**ADDENDUM #1**

August 3, 2010  
Bowie State University's Bidder's List  
IFB #BSU 2011-01 McKeldin Gymnasium Roof Replacement

**ADDENDUM #1**  
**IFB #BSU 2011-01, MCKELDIN GYMNASIUM ROOF**  
**REPLACEMENT**

**SHEET TITLE** PROPOSED DETAILS - ALTERNATE #4 NAILBASE INSULATION  
**PROJECT TITLE** THEODORE MCKELDIN GYMNASIUM ROOF REPLACEMENT  
**ADDENDUM #1** ISSUE, JULY 30, 2010  
BOWIE STATE UNIVERSITY  
14000 JERICHO PARK ROAD  
BOWIE, MD 20715-9405

**DRAWING NO:**  
**A802**

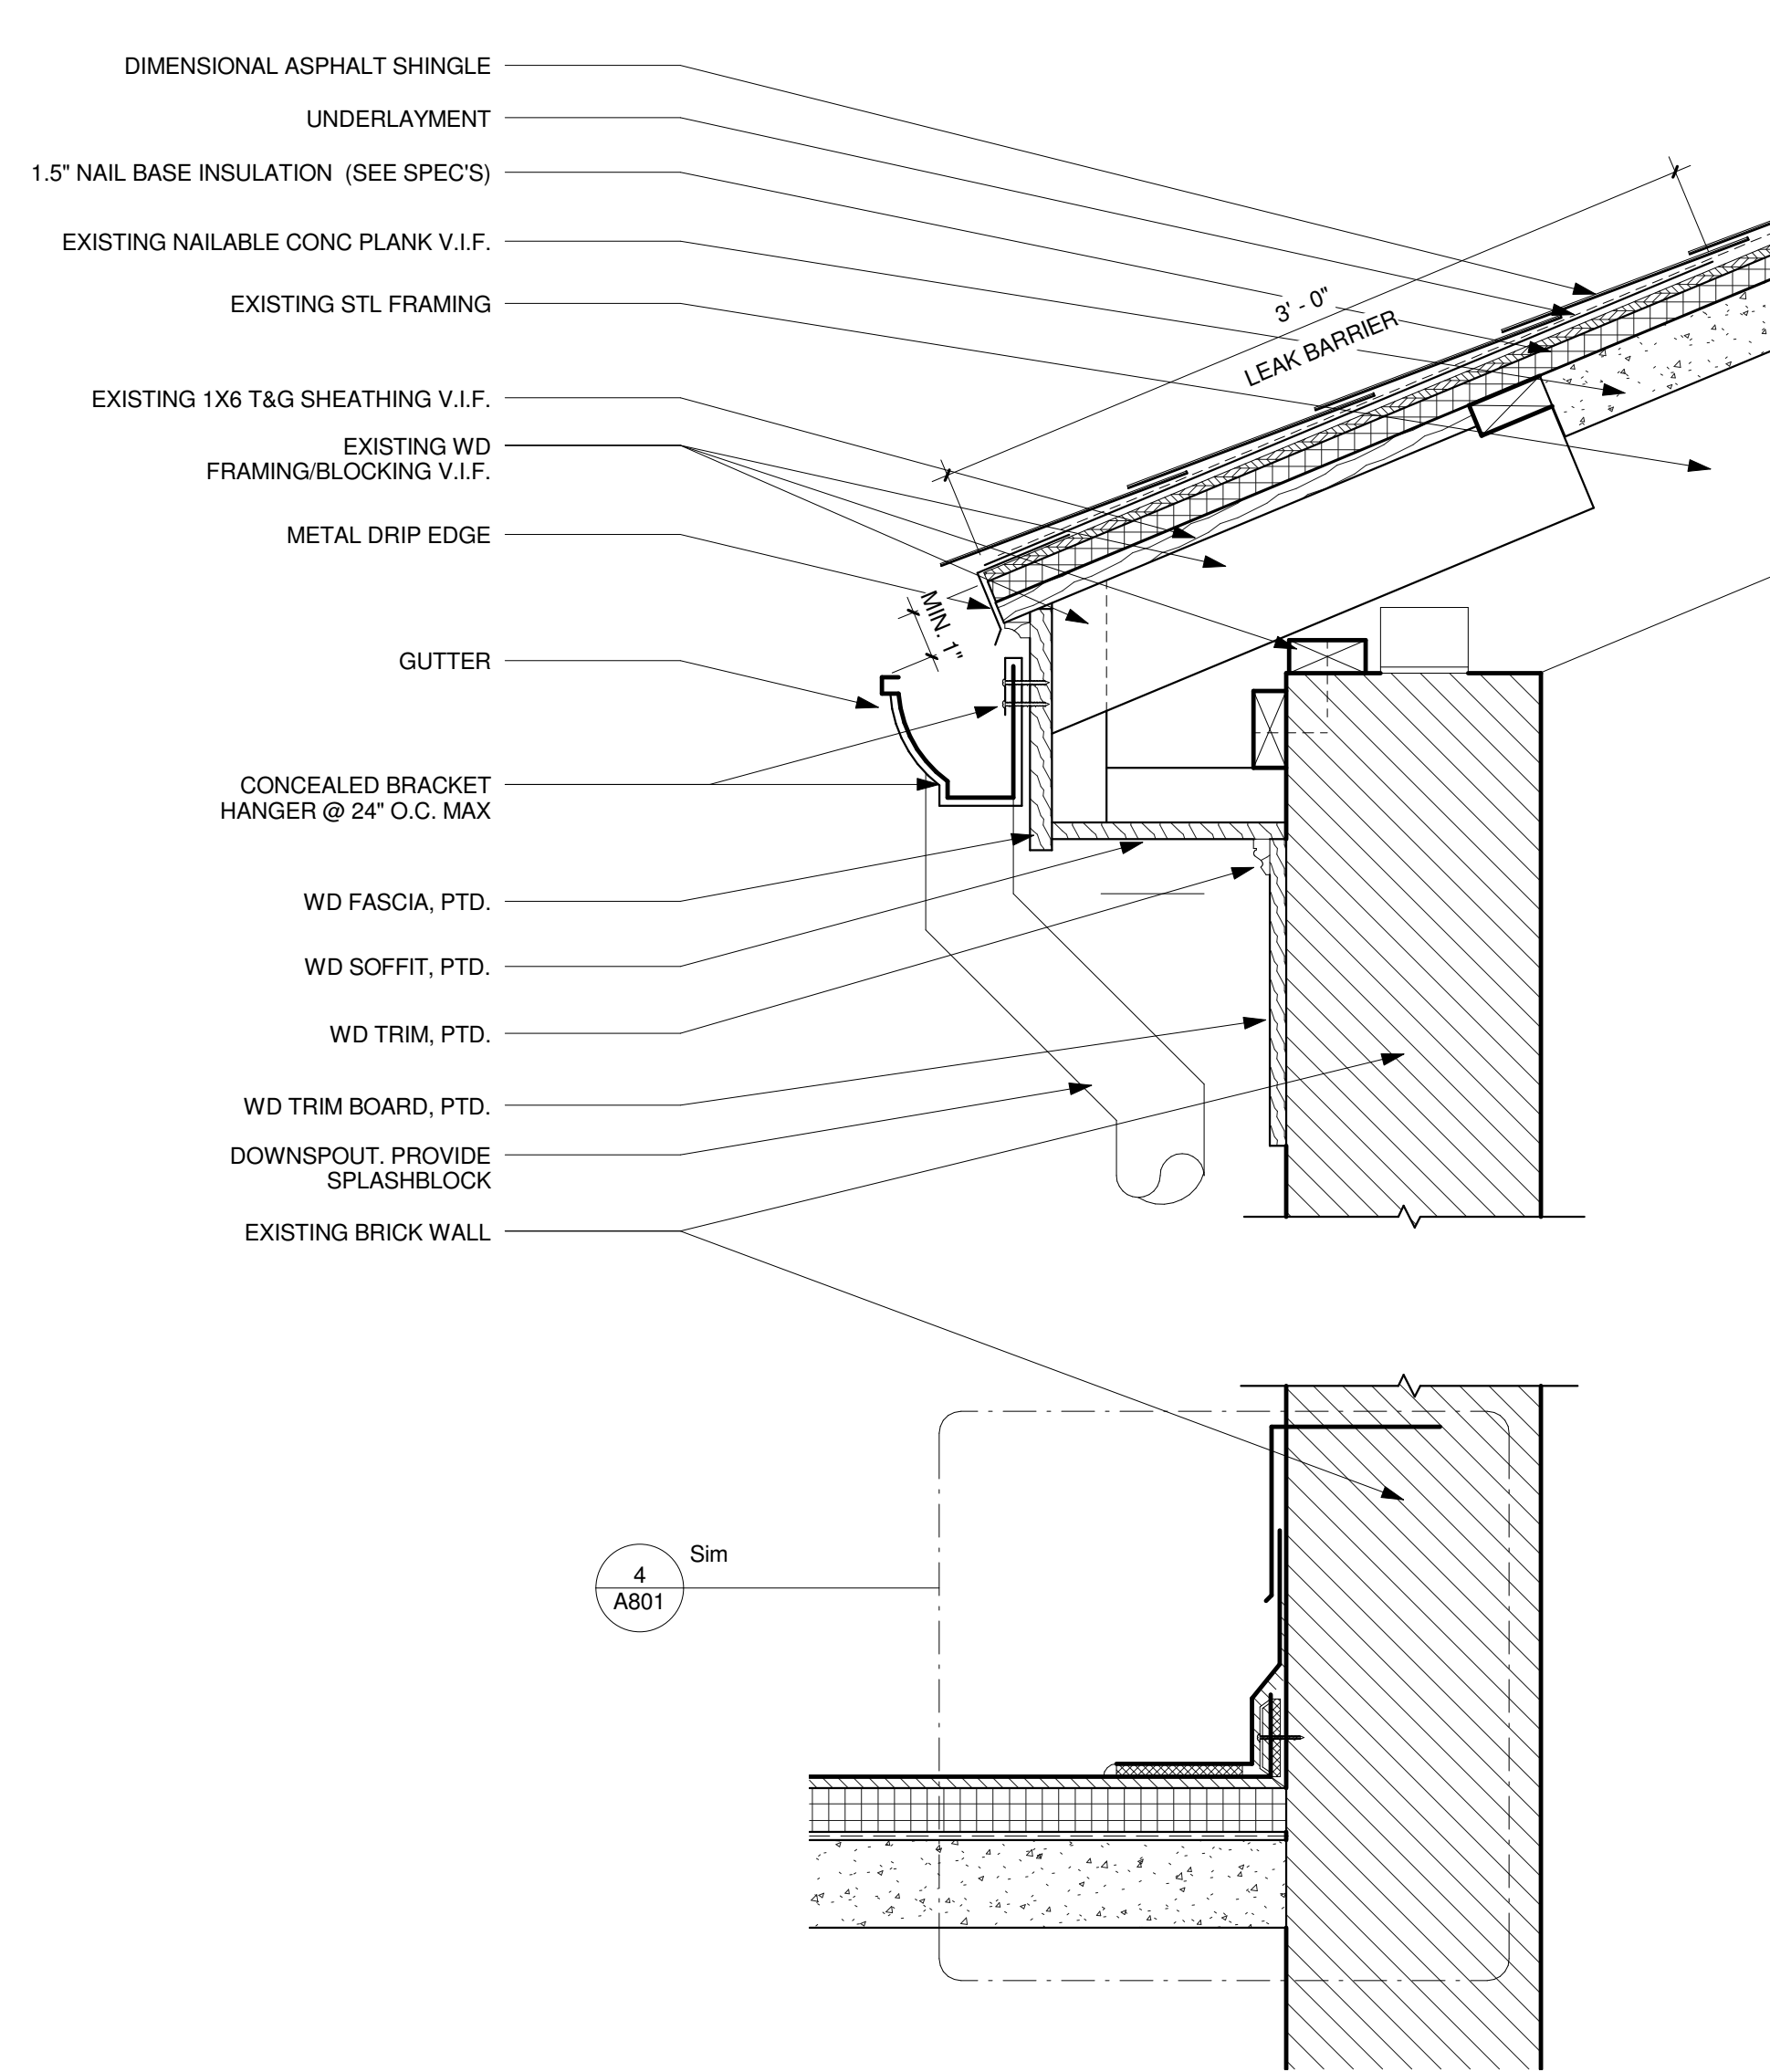
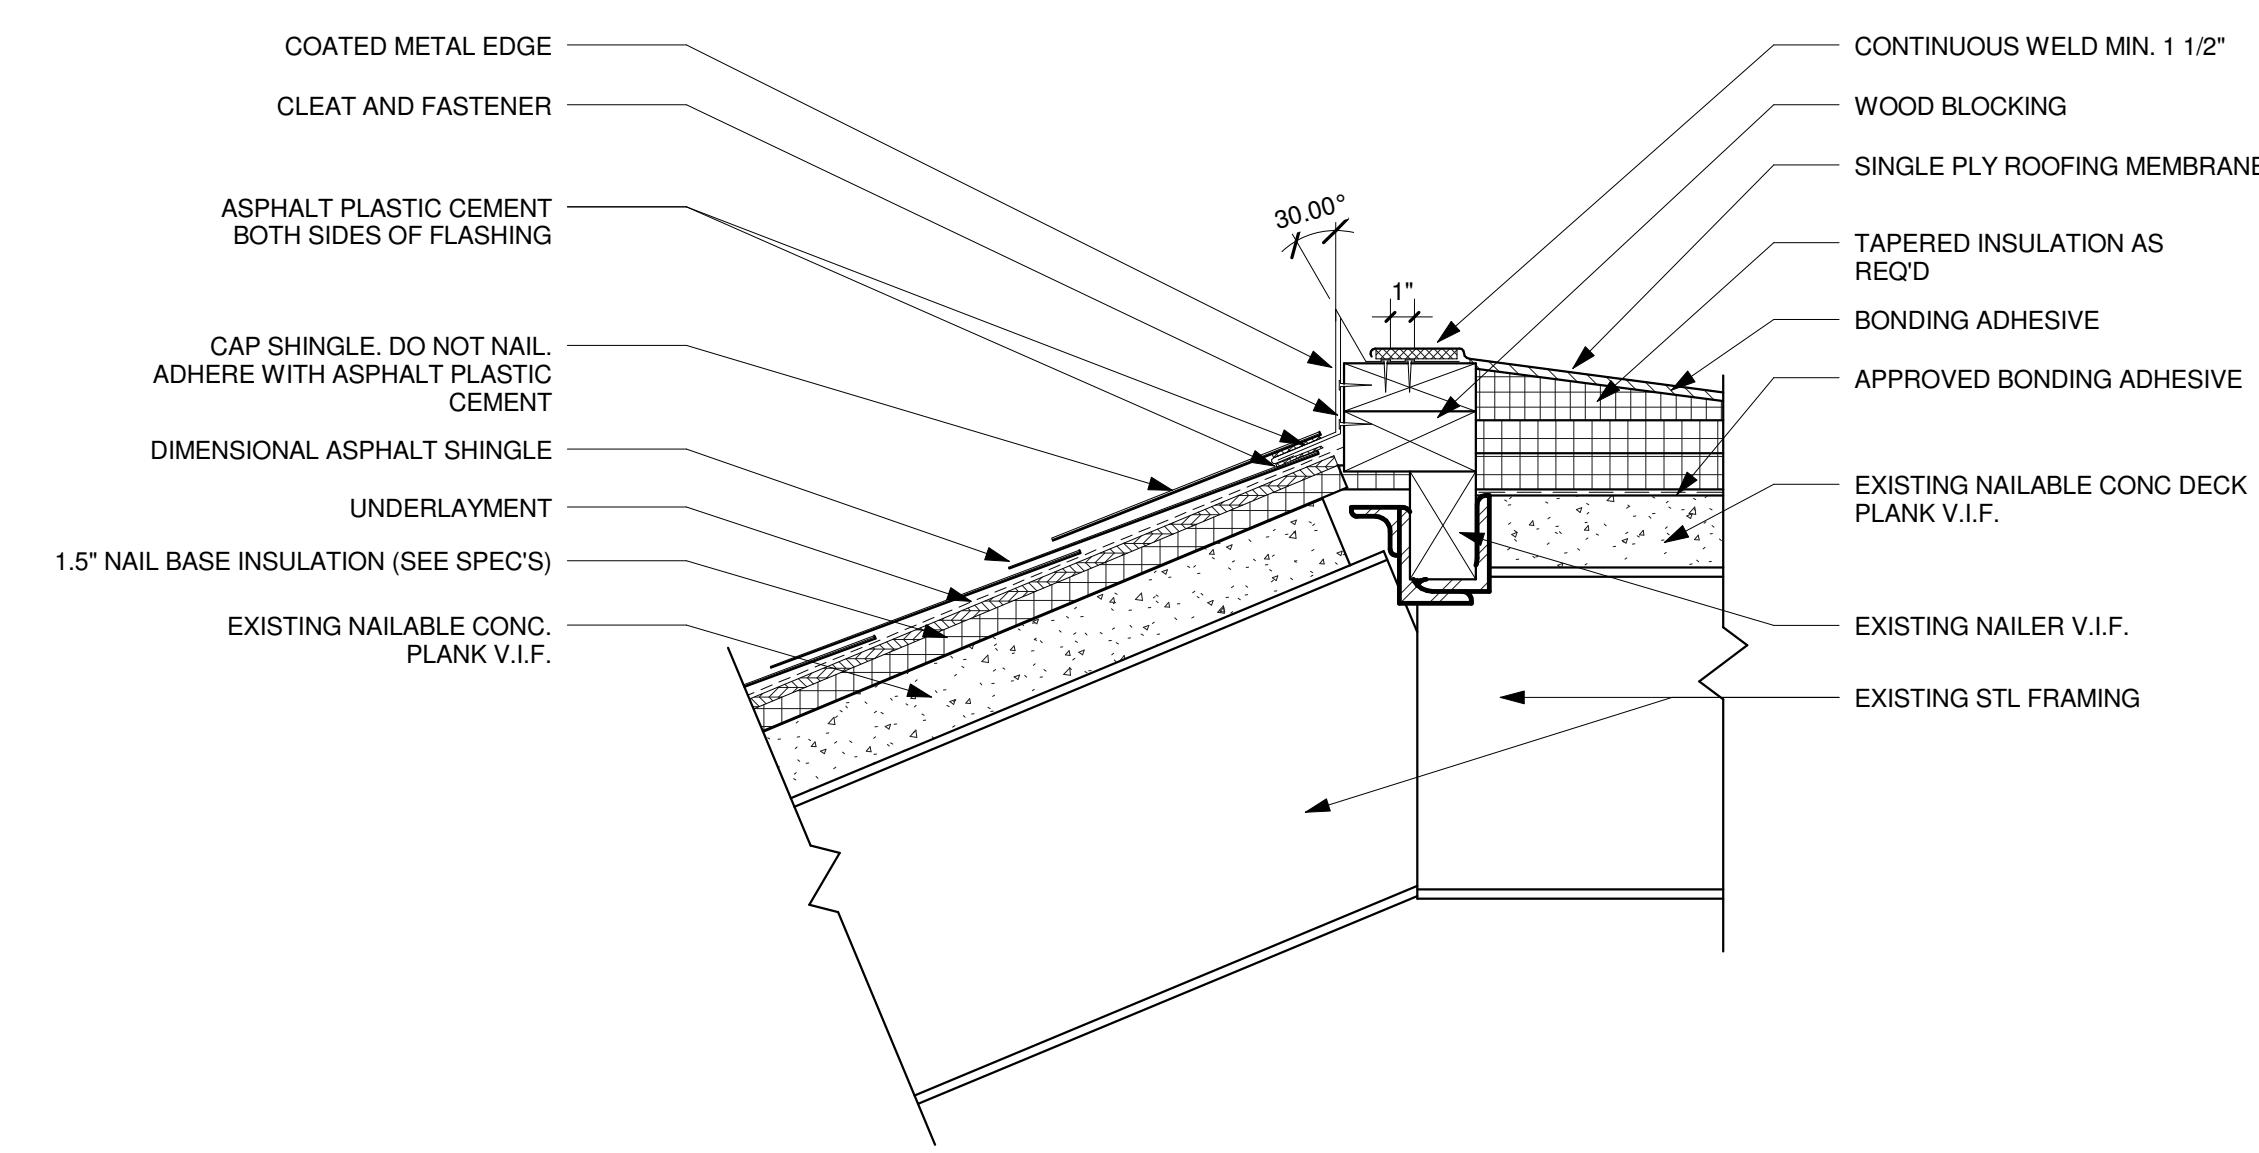
Attached and made a part of this IFB is drawing sheet A802, an addition to the 'BID SET ISSUE' drawings. This sheet will be an addition to the sheets already in the set that is posted for bids.

Sheet A802, details and specifies a substitute 'NAILBASE INSULATION' for the sloping/shingle section of the roof and is necessary for the pricing in the bid as concealed conditions may require the use of this product.

It is a Bid-Alternate to be used in lieu of the insulation called for in the 'BID-SET ISSUE'.
